MODIFICATION #2
WEST LILAC ROAD OVER I-15 BRIDGE
DEPARTMENT OF PUBLIC WORKS

**Request for a
Modification to a Road Standard
and/or to Project Conditions**

Project Number: TM 5571/5572 Date of Request: Sep. 12, 2012

LILAC HILLS RANCH: 2.2C LIGHT COLLECTOR MODIFICATION TO ROAD STANDARDS

ATTACHMENT 1

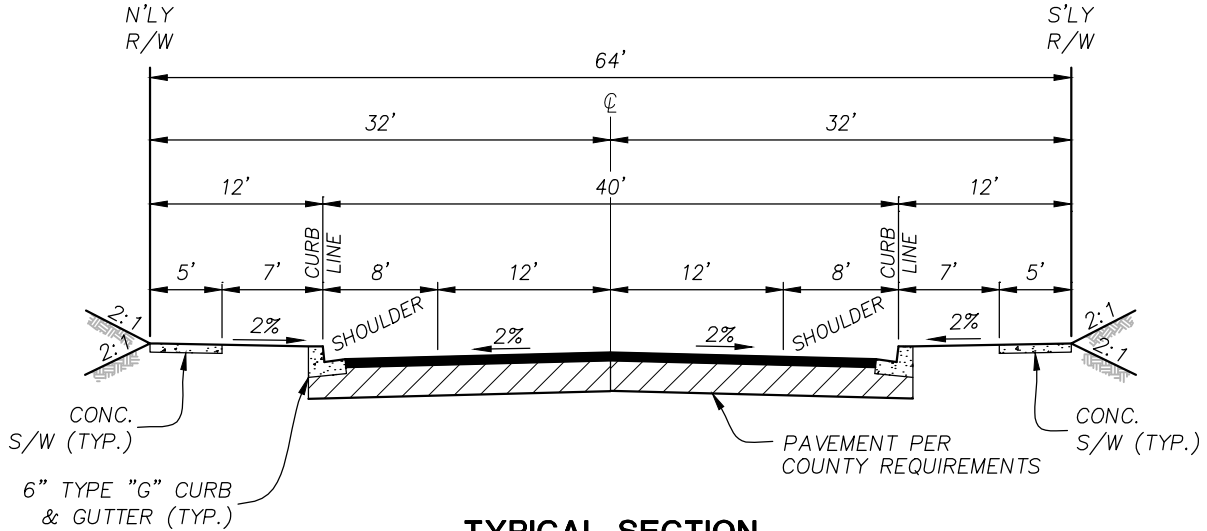
The standard road section for Light Collector Road 2.2C is 40'-54' wide curb to curb
width on 64'-78' r/w with a minimum design speed of 40 mph. The requested modification
to the road standard is to require no widening of the existing 40' wide West lilac Road
bridge over I-15 and allow only re-striping and the addition of curb, gutter and sidewalk
on one side of the road (see attachment 1).

**PROPOSED TYPICAL SECTION
(2.2C LIGHT COLLECTOR)
WEST LILAC RD OVER I-15 BRIDGE**

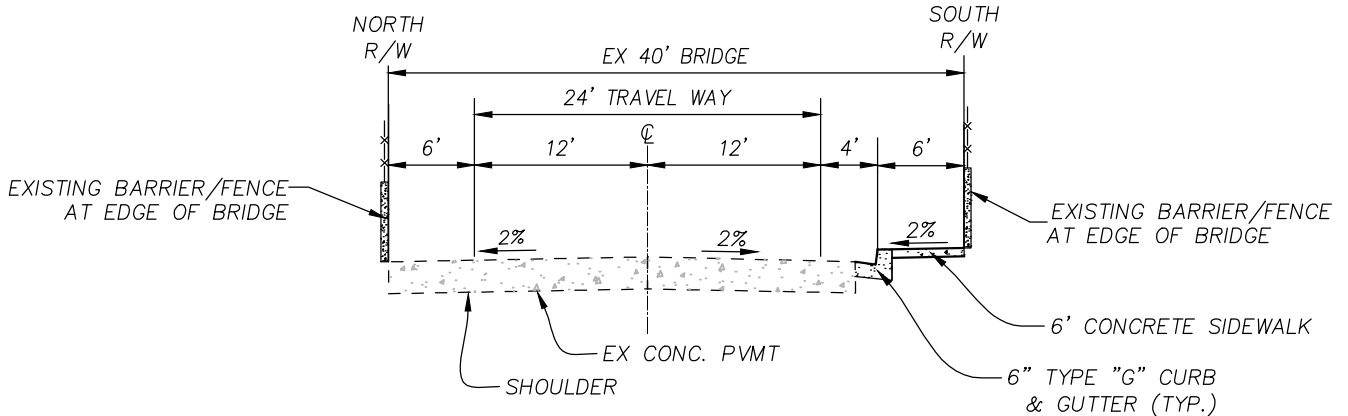
The existing 40' wide bridge section has a 24' travel way with 8' shoulders on each
side. A proposed widening of the bridge would be extremely expensive, extremely
disruptive to anyone that uses West Lilac Road & I-15, and would alter the beauty and
historic nature of the bridge (see attachment 2). The modified road would also allow
for safer pedestrian traffic over the bridge.
